## St Joseph's College Physical Education and Sports Precinct Project (PESPP) (SSD 8970)

### RESPONSE TO SUBMISSION

Prepared on behalf of St Joseph's College

13 May 2019 | 16037

**Figure 1 – Built form Gladesville Road/Luke Street: Original SSDA and RtS Amended SSDA**

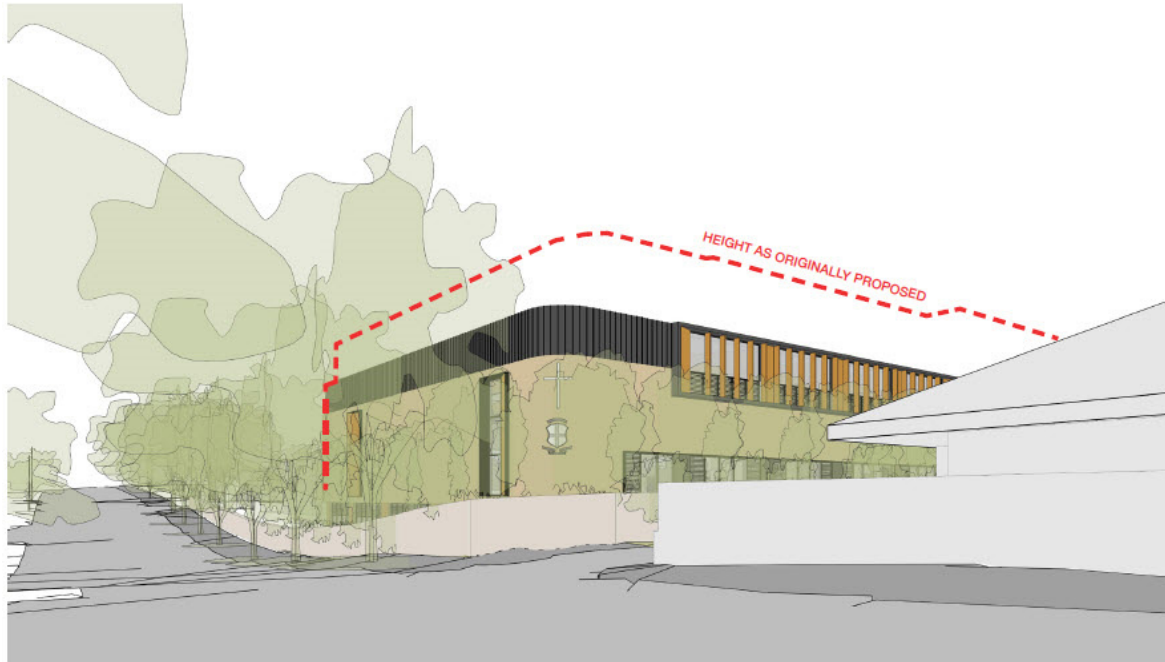
- *The Department considers that the proposed bulk and scale of the Physical Education and Sports Precinct (PESP) building is excessive and would not be compatible with the character of the immediately locality or the heritage values of the Hunters Hill Conservation Area No 1—The Peninsula. The bulk and scale of the PSEP building would dominate both street frontages due to its height and lack of setbacks to the boundary.*

- *The Department considers that opportunities to reduce the mass of the PSEP building and increasing the setbacks of the building from the site boundaries, must be explored. These may include additional excavation (to reduce the overall height), deleting components of the building on the upper level such as meeting rooms and / or reducing the overall building footprint.*

- *Additional photomontages, comparing the scale of the PSEP building with the existing buildings within the site and also in the locality (streetscape sections and overall site sections), must be provided to enable detailed assessment of the visual impacts of the bulk and scale of the proposed building*

1. **Luke Street Setback:** A 4.3m building setback to Luke Street is proposed (compared with 1.3m in the Original SSDA). The proposed setback allows the majority of trees on Luke Street and Gladesville Road to be retained (approximately existing 20 trees) and provides for the planting of 21 new trees within a landscape buffer located between the PESPP and stone wall. The increased setback also simplifies the required construction solution to protect the stone wall.

2. **Building height:** A 2.7m reduction in the height of the parapet and ridge of the main roof is proposed (-19%). This is achieved by increasing the excavation depth to lower the entire building and relocating the roof plant away from Luke Street. The amended *building height* of the parapet and ridge, which varies along Luke Street and Gladesville Road, is predominantly 11.4m compared with 14.1m in the Original SSDA.

Images including (photomontages) comparing the existing, Original SSDA and Amended SSDA follow at **Figures 1 to 5** showing the proposed reduction in height, bulk and scale achieved from the proposed reduction in height and increased Luke Street setback.
